**APPLICATION FOR
URBAN DESIGN COMMISSION
REVIEW AND APPROVAL**

RE: **MERITER WELLNESS CENTER
ARBOR GATE DEVELOPMENT
2501 W. BELTLINE HWY.
FINAL APPROVAL FOR "SECONDARY TENANT" SIGNAGE**

| TITLE: 2501 and 2601 West Beltline Highway – Comprehensive Design Review. 14 th Ald. Dist. (10706) | REFERRED: REREFERRED: REPORTED BACK: |

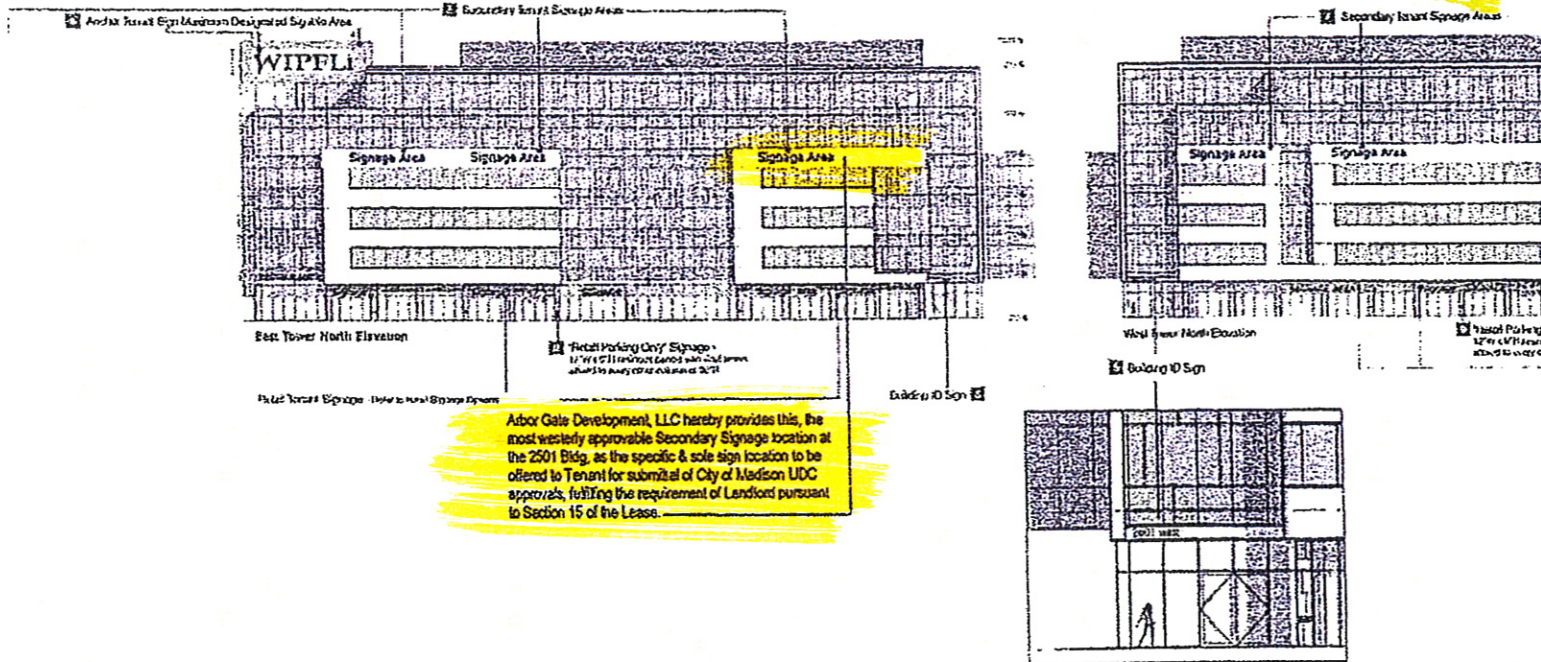
Per the terms of approvals granted 7/9/08 by the City of Madison UDC, there shall be no more than two (2) Bellline Facing Secondary Signs located on the Secondary Signage Band for the 2501 Building, of the three (3) possible, approvable locations shown in this Exhibit, below.

Arbor Gate Development, LLC hereby provides this, the most westerly approvable Secondary Signage location at the 2501 Bldg, as the specific & sole sign location to be offered to Tenant for submittal of City of Madison UDC approvals, fulfilling the requirement of Landlord pursuant to Section 15 of the Lease.

Ryan Signs, Inc.
 3007 Perry Street • Madison, WI 53713 • Tel: (608) 271-7979 • Fax: (608) 271-7853
MERITER - WELLNESS CENTER

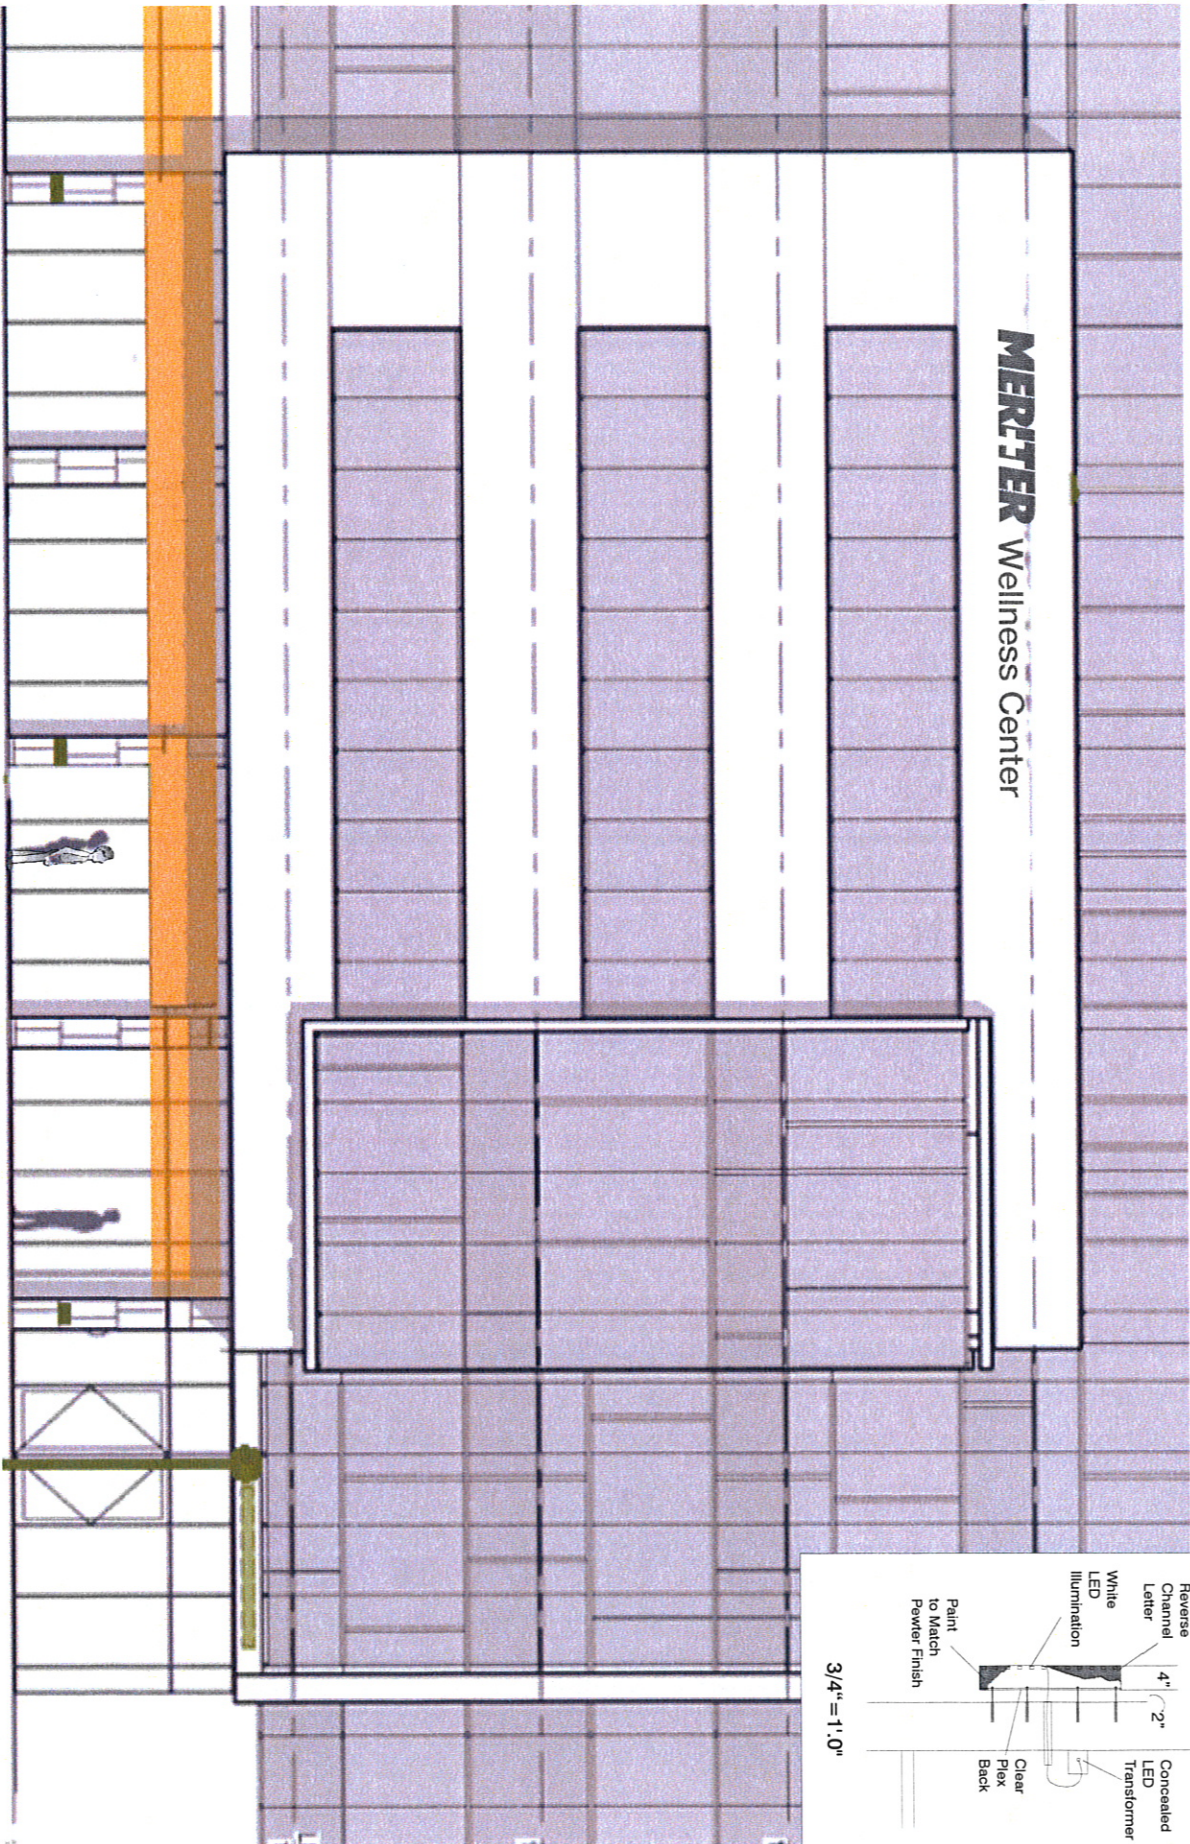
- a. To allow for the installation of the **Meriter Wellness Center** letters on the secondary tenant façade (location as approved by the UDC in July 9, 2008). The location is the western stone façade on the East building.
- b. The sign will include **24" Meriter** letters and **16 ½" Wellness Center** letters.
- c. The letter styles will be per Meriter's corporate standard.
- d. The letters will have fabricated aluminum faces and sidewalls. The letters will be back-lit using white LED.
